# EIGHTEEN SUNSET

DESIGN REVIEW BOARD

FINAL SUBMITTAL JANUARY 4, 2021

DESIGN REVIEW BOARD *PROPOSED*

# ROOF DECK PROPOSED

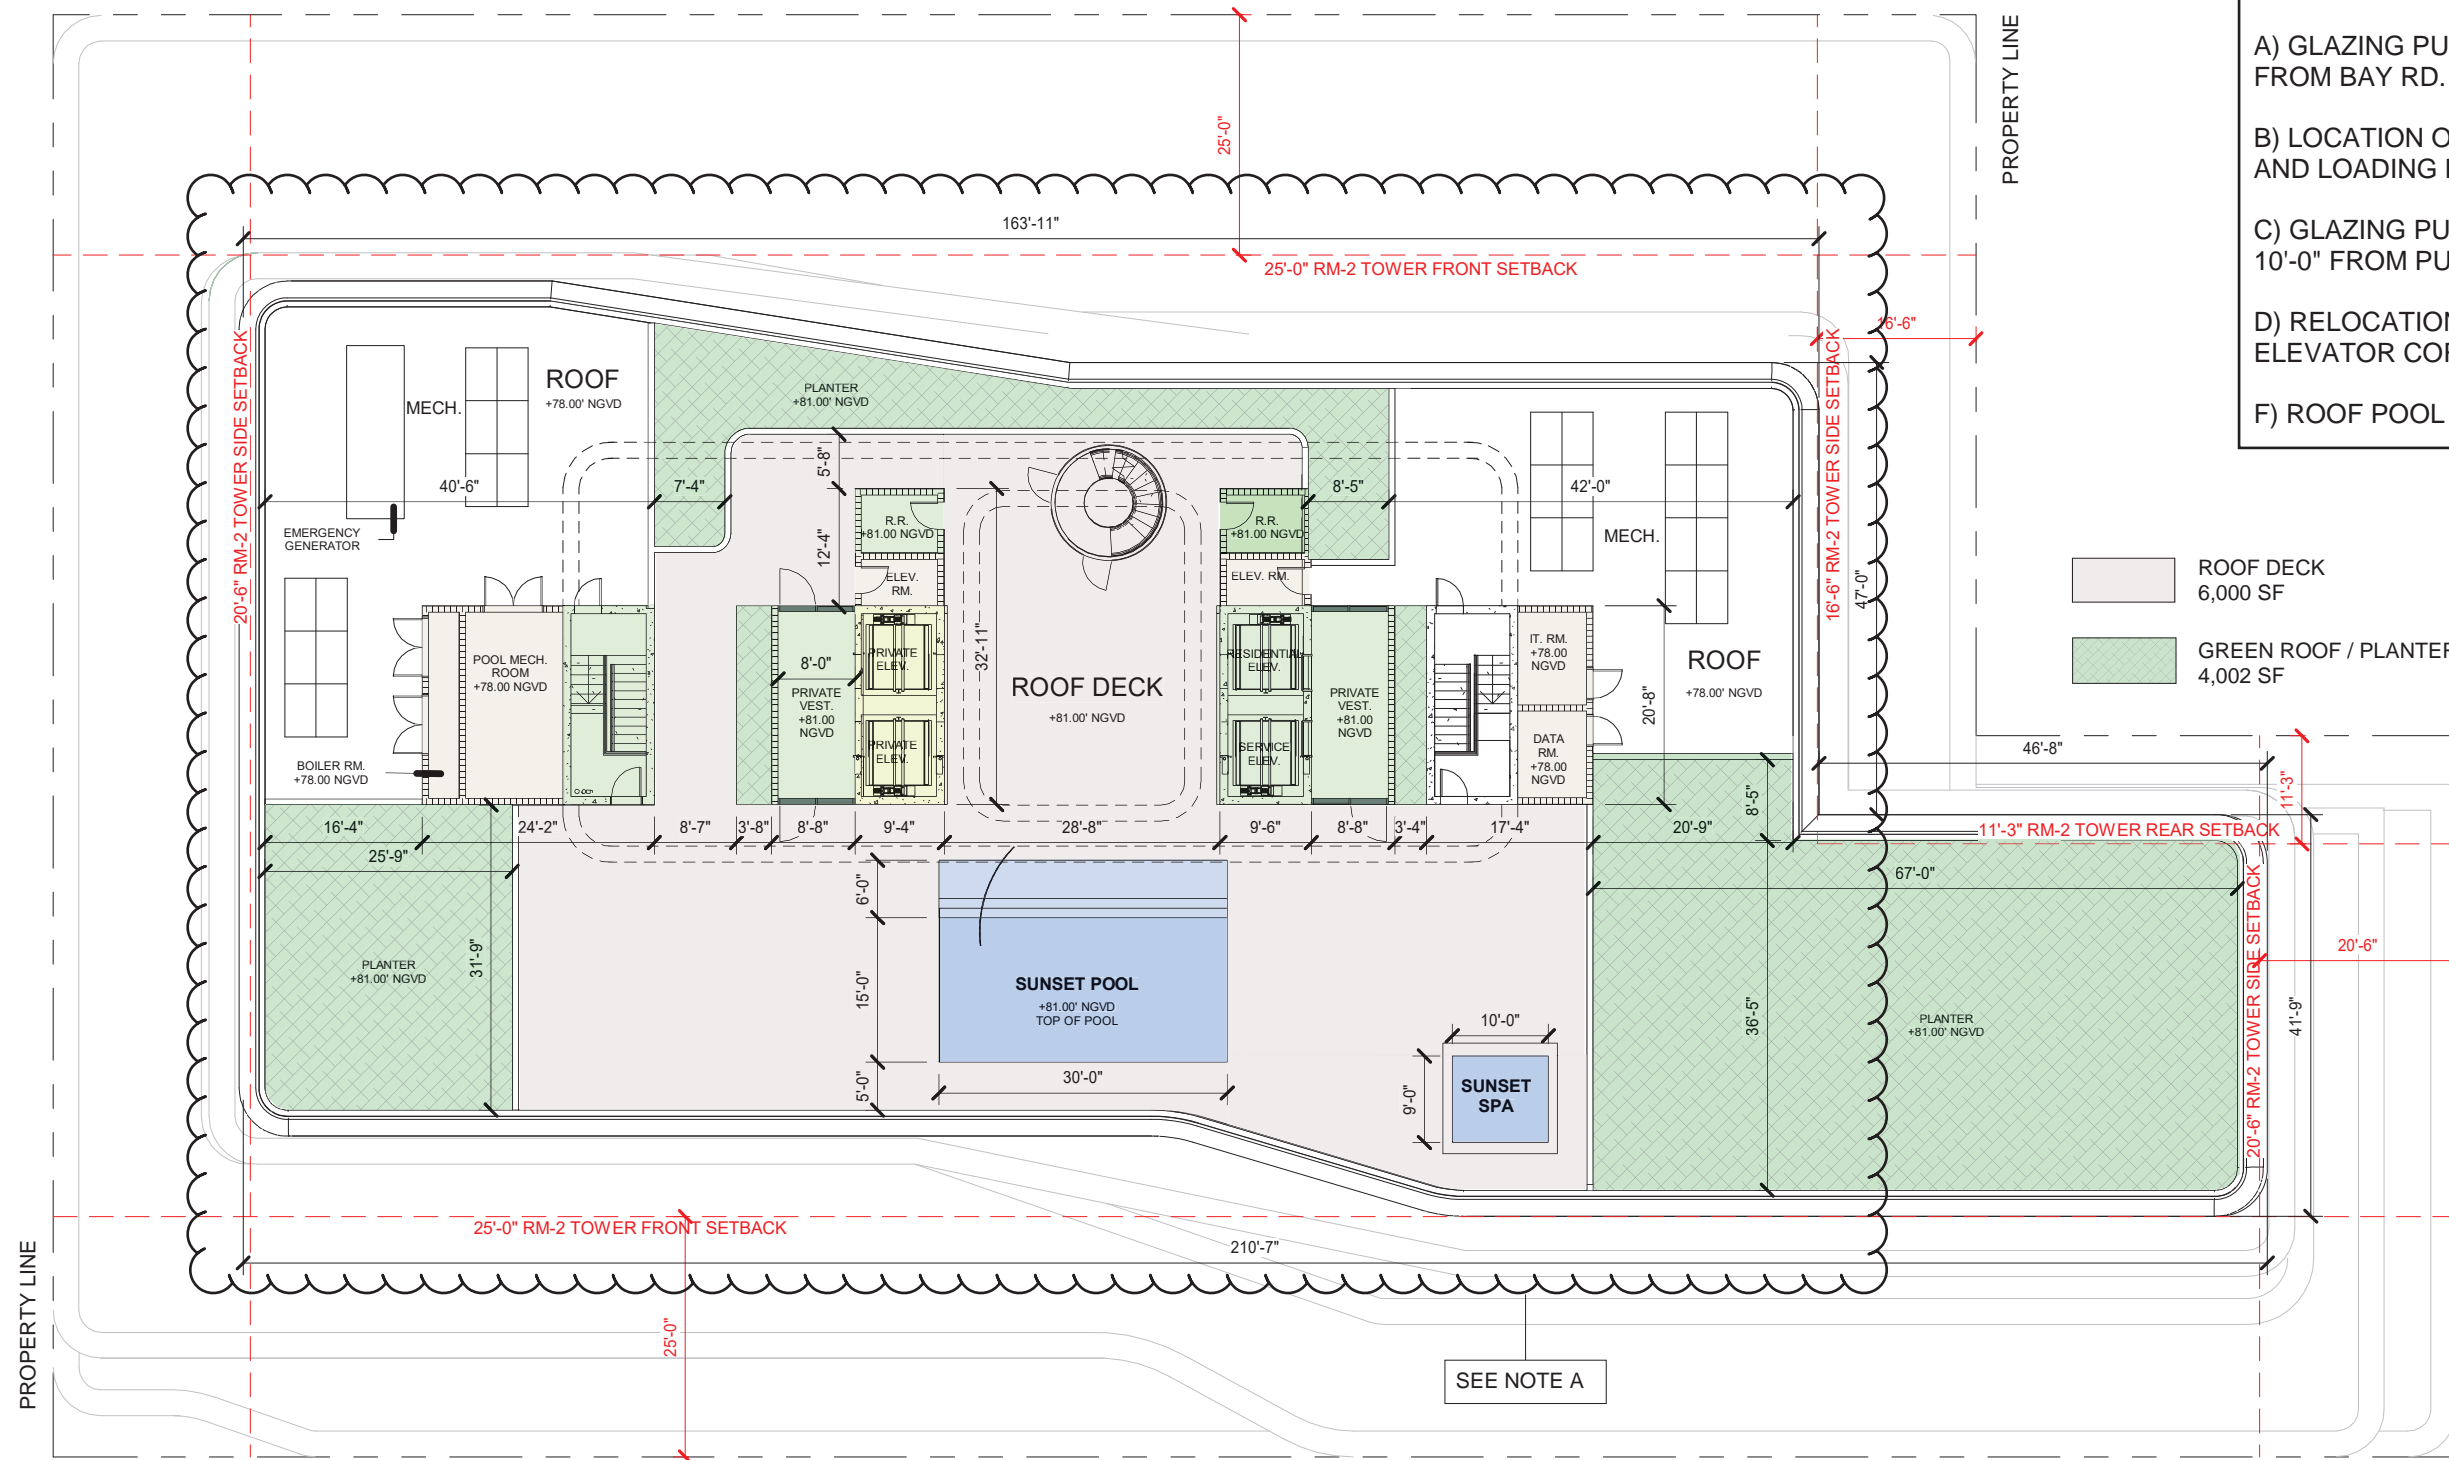
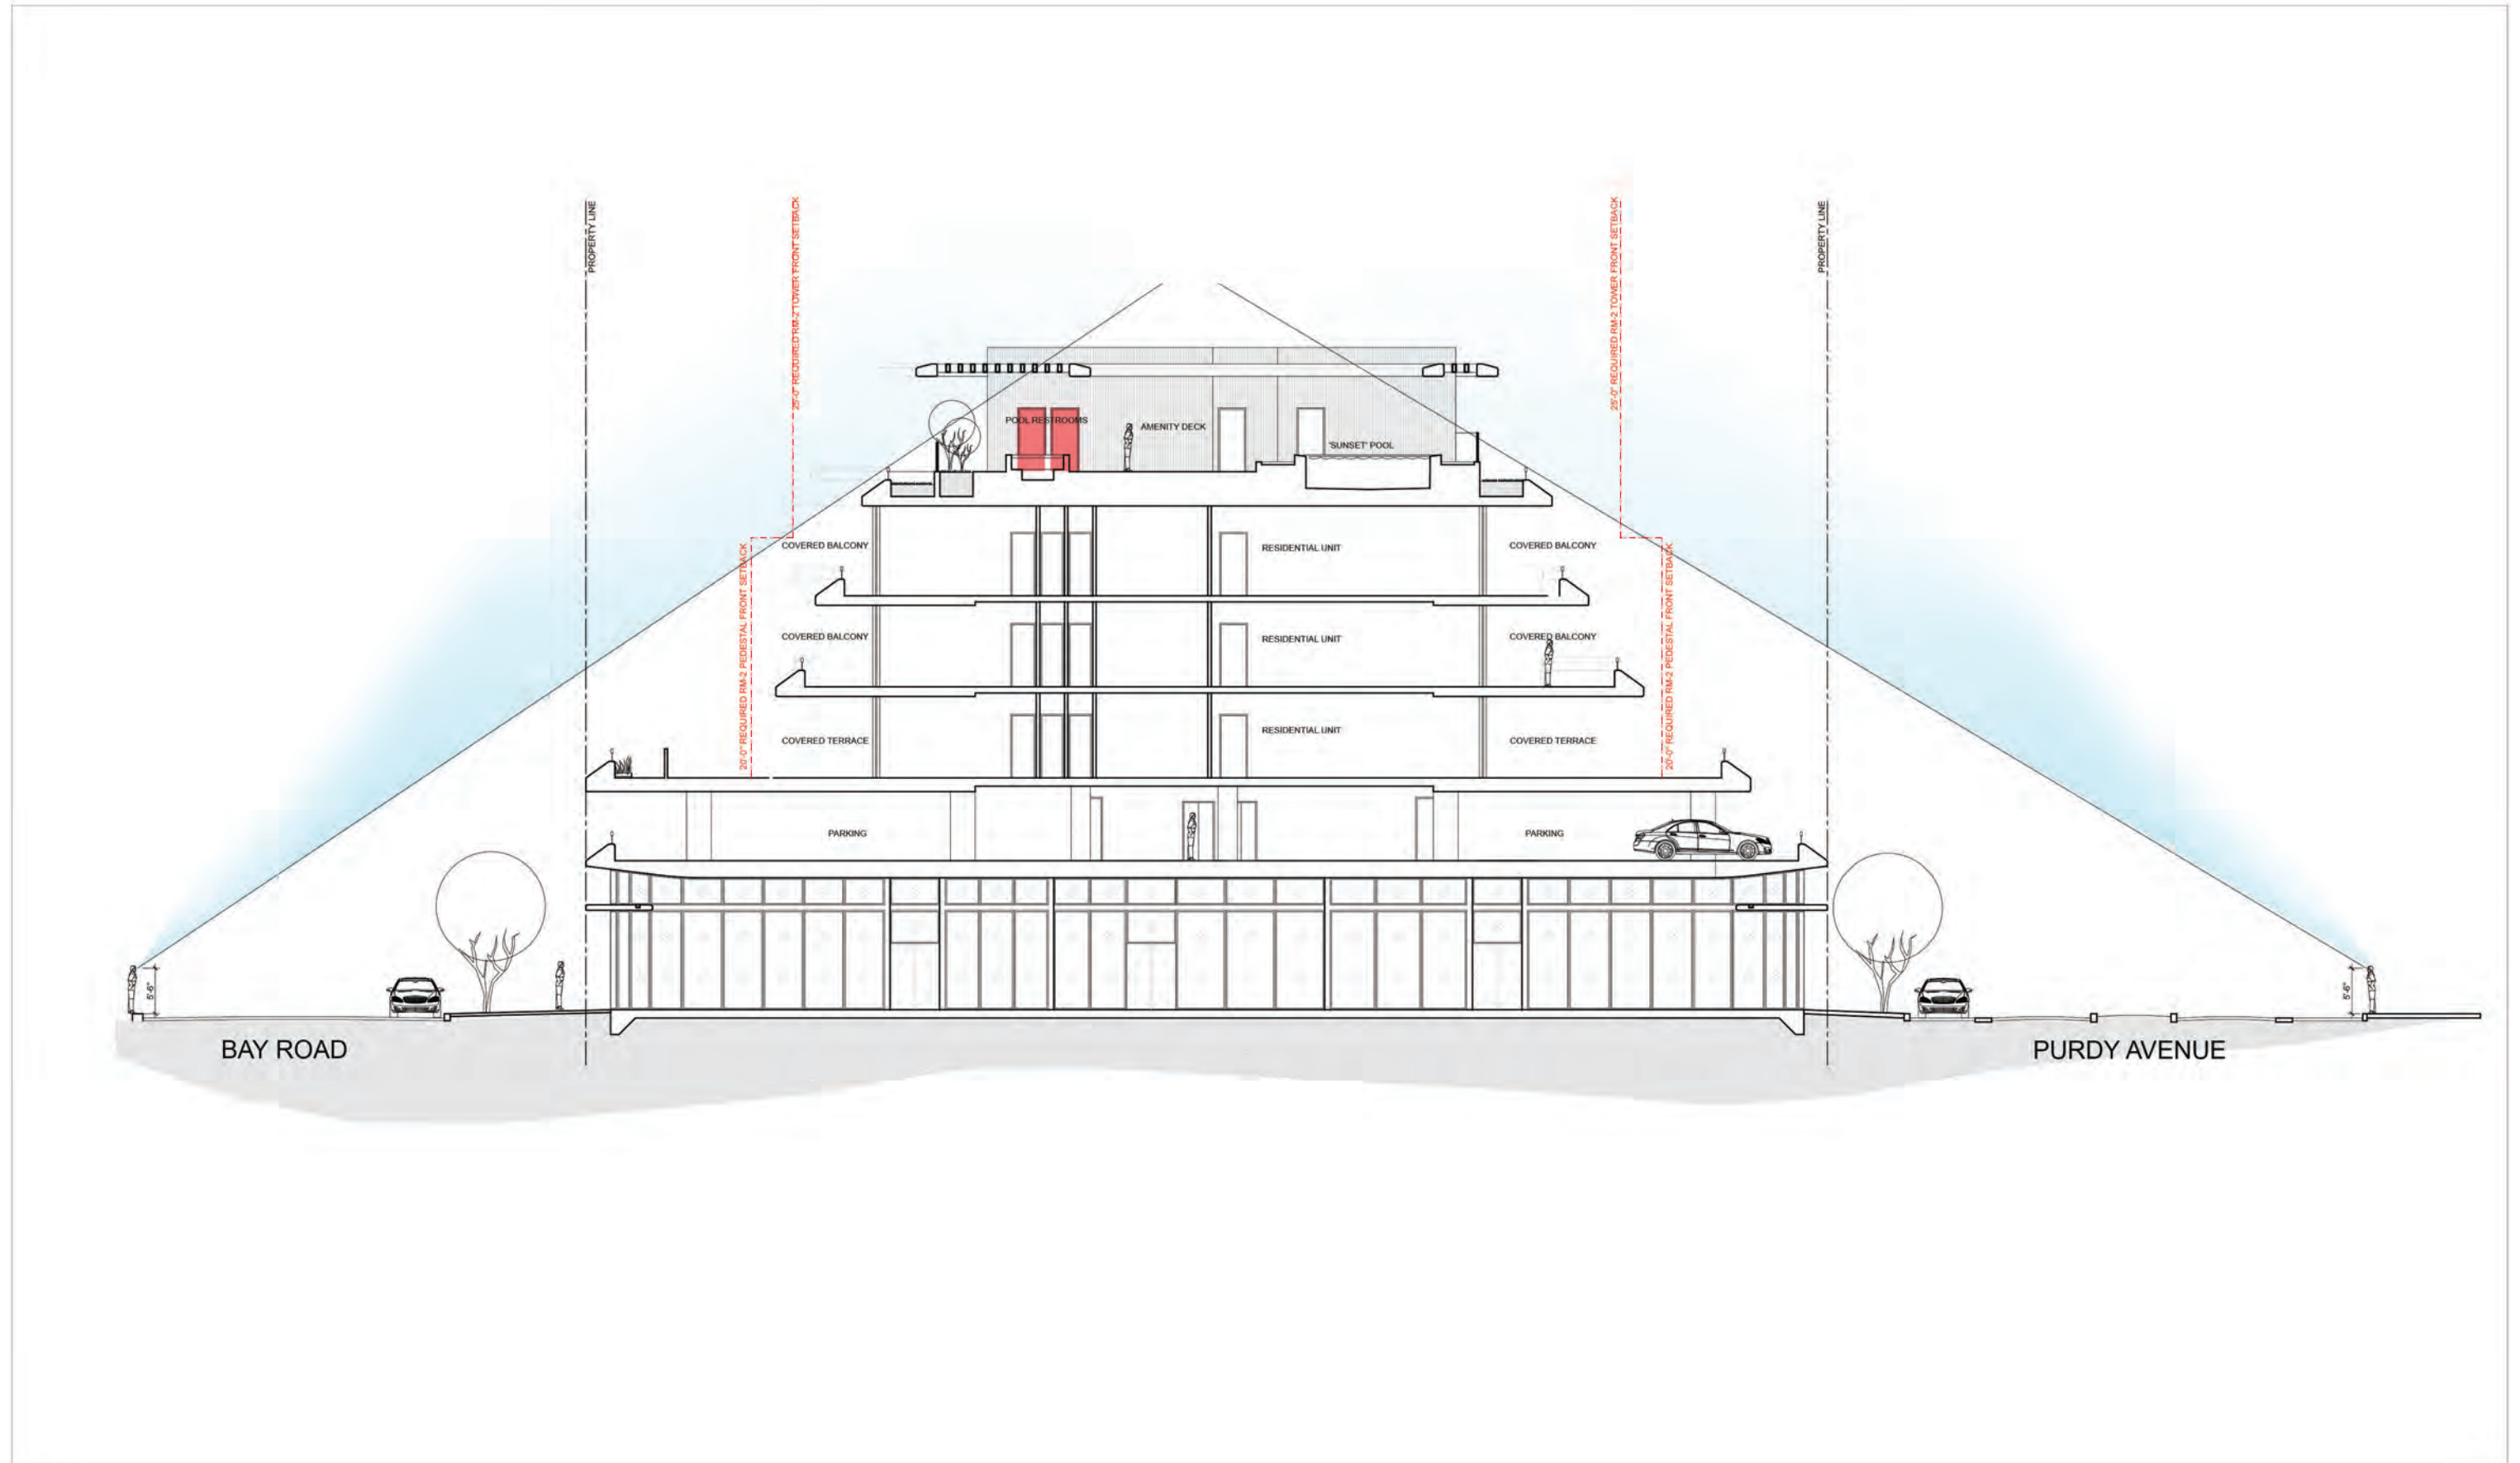
**NOTE A:**  
 CHANGES TO BE APPROVED ADMINISTRATIVELY. NOT PART OF THIS APPLICATION.

- A) GLAZING PUSHED BACK 8'-0" FROM BAY RD.
- B) LOCATION OF GARAGE RAMP AND LOADING DOCK FLIPPED
- C) GLAZING PUSHED BACK 10'-0" FROM PURDY RD.
- D) RELOCATION OF STAIR AND ELEVATOR CORES
- F) ROOF POOL RELOCATED

# WEST ELEVATION (PURDY) PROPOSED

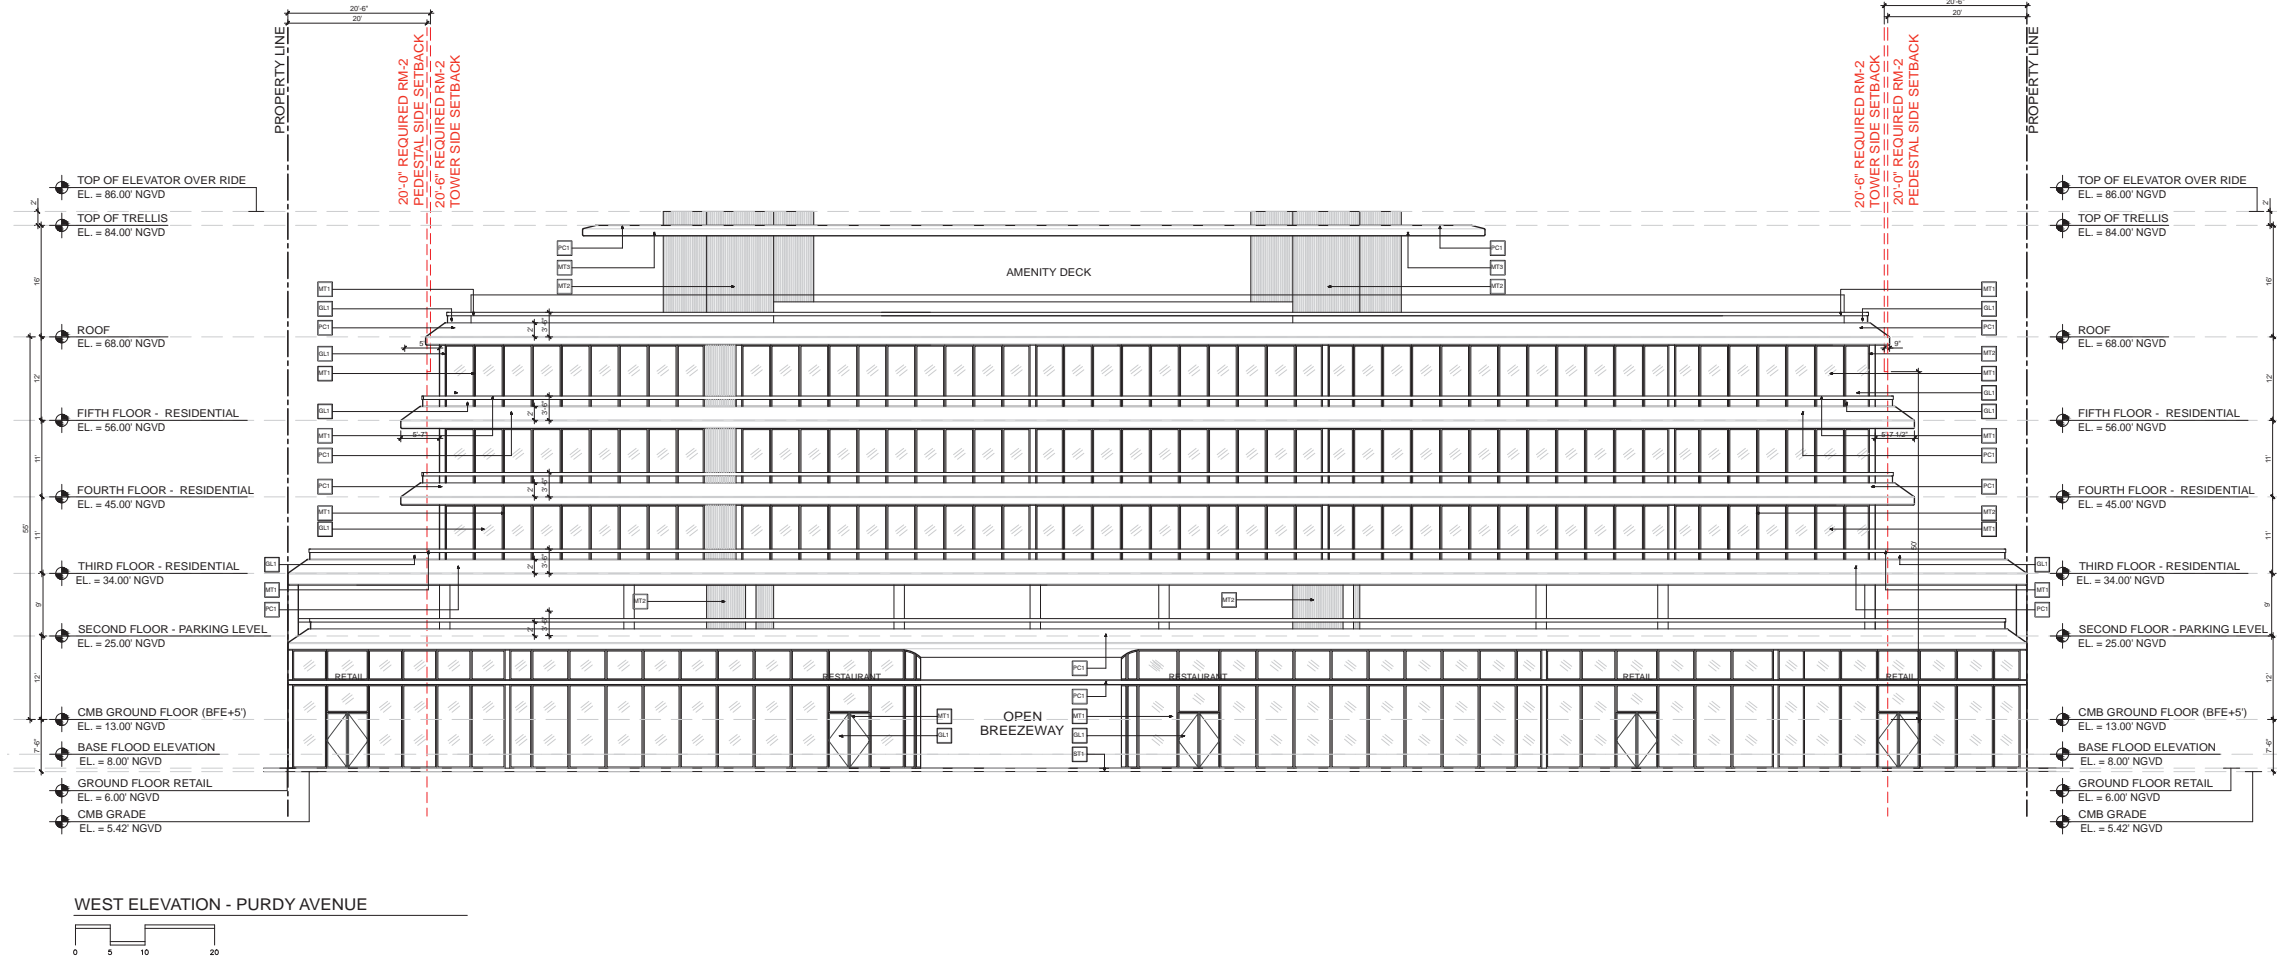
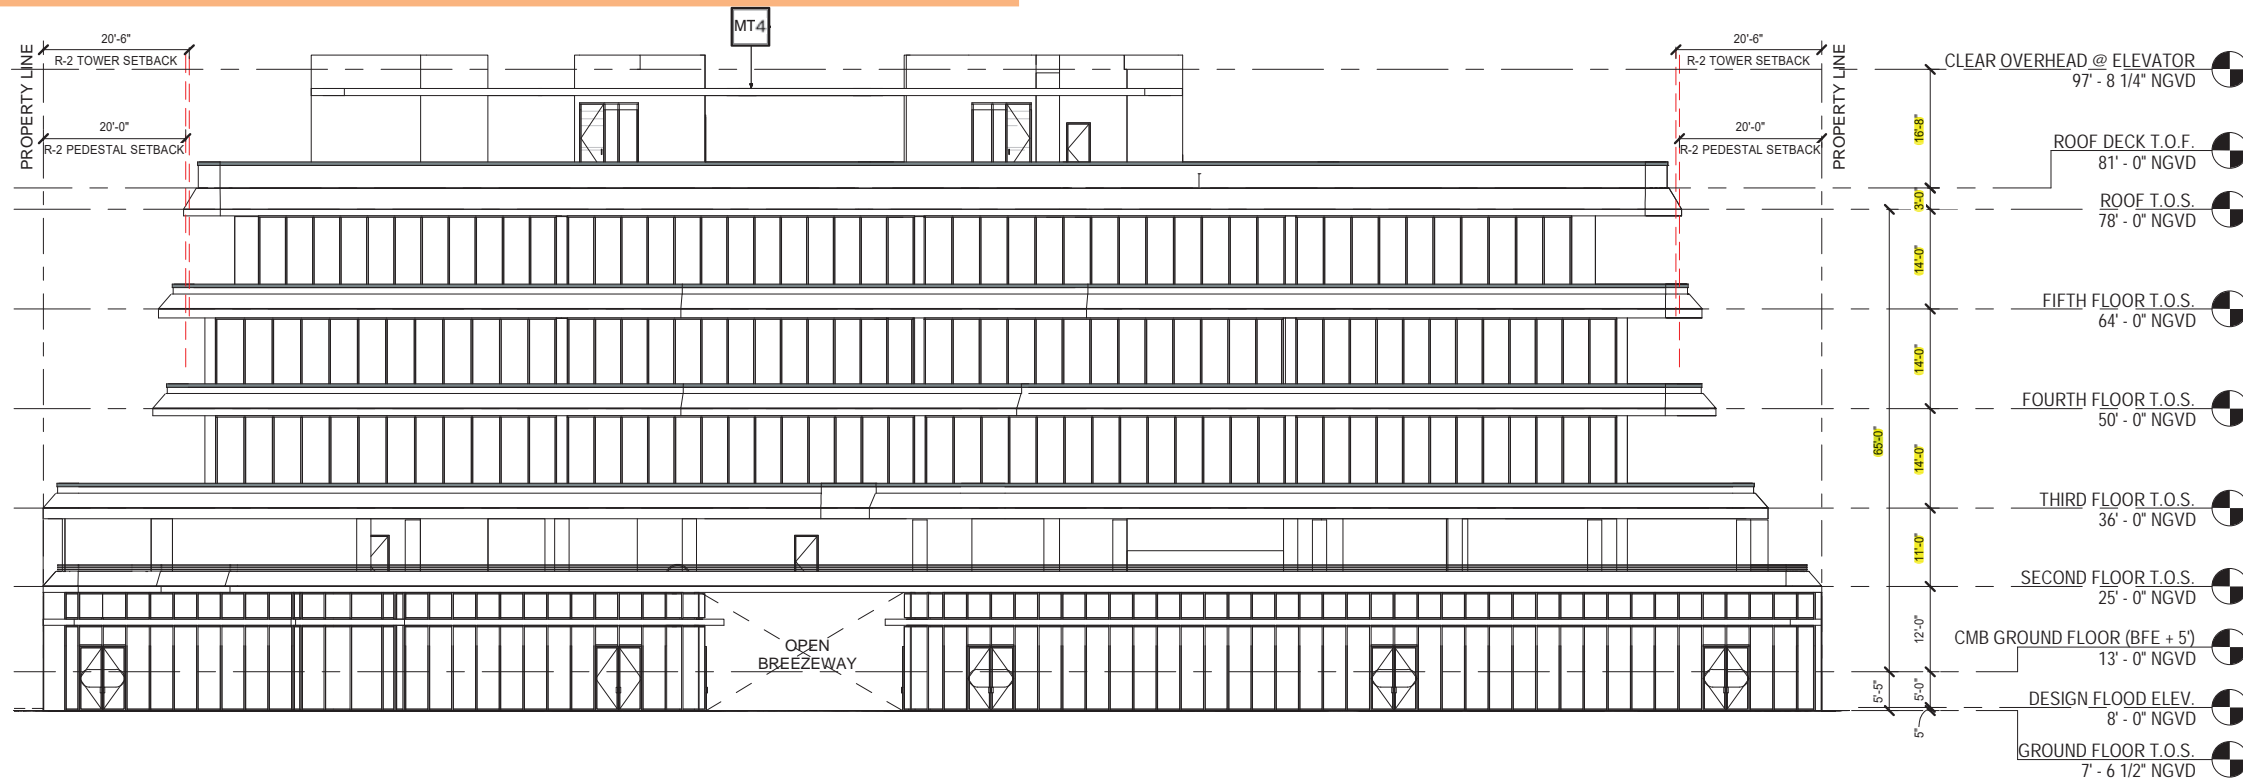
ALL MATERIALS ARE EITHER STUCCO OR GLASS  
EXCEPT ALUMINUM TRELLIS
